CONTRACT CHANGE ORDER NO. 322S2
SHEET 2 OF 2

MARK	DATE	DESCRIPTIONS	BY	CH'D	CCO#
3	10/21/13	TRAVELER FIELD ISSUES	DT	TH	322S2
2	08/23/13	MODIFY TRVELER RAIL ANCHORAGE	DT	TH	322S1
1	05/18/09	TRAVELER RAIL MODIFICATIONS	TH	RM	24S0
0	07/20/07	RAIL CHANGE AND MISCELLANEOUS DETAILS	TH	RM	24

SAN FRANCISCO OAKLAND BAY BRIDGE
EAST SPAN SEISMIC SAFETY PROJECT
SELF-ANCHORED SUSPENSION BRIDGE
(SUPERSTRUCTURE & TOWER)

SKYWAY TRAVELER RAIL REPLACEMENT DETAILS NO. 4

UPPER RAIL SUPPORT DETAILS AT CIP CONCRETE CLOSURE

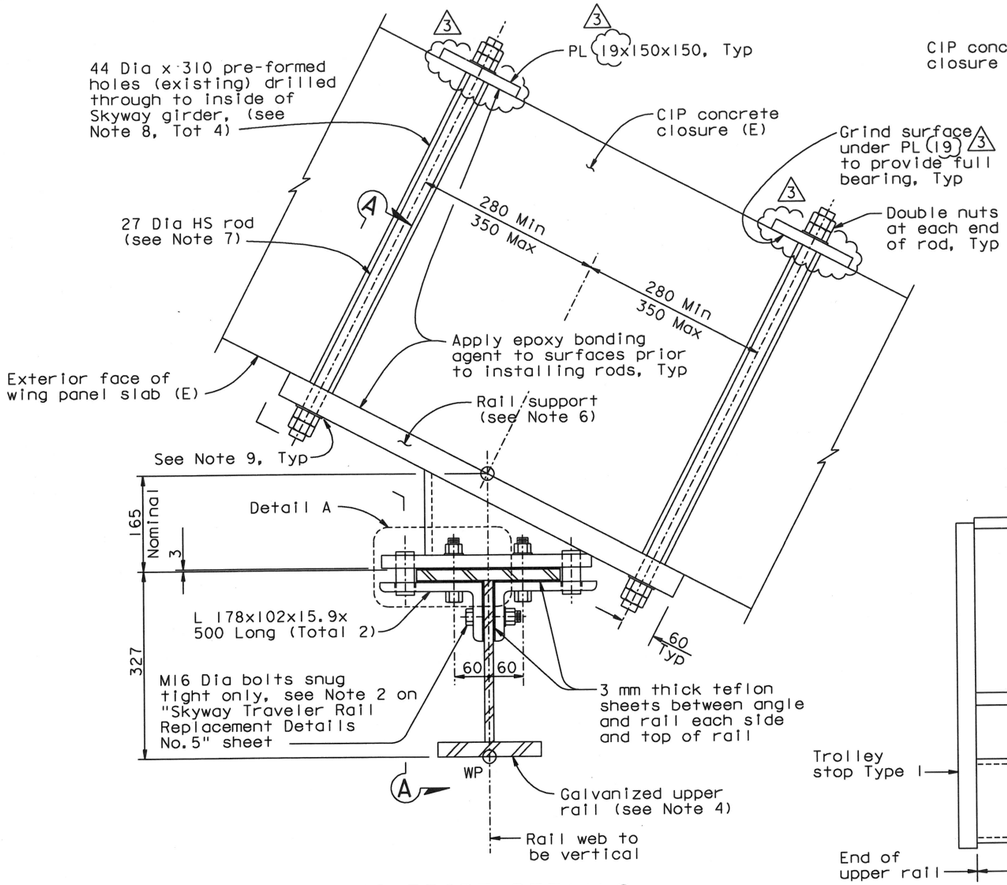
REVISION 1 SUPERSEDES REVISION 0
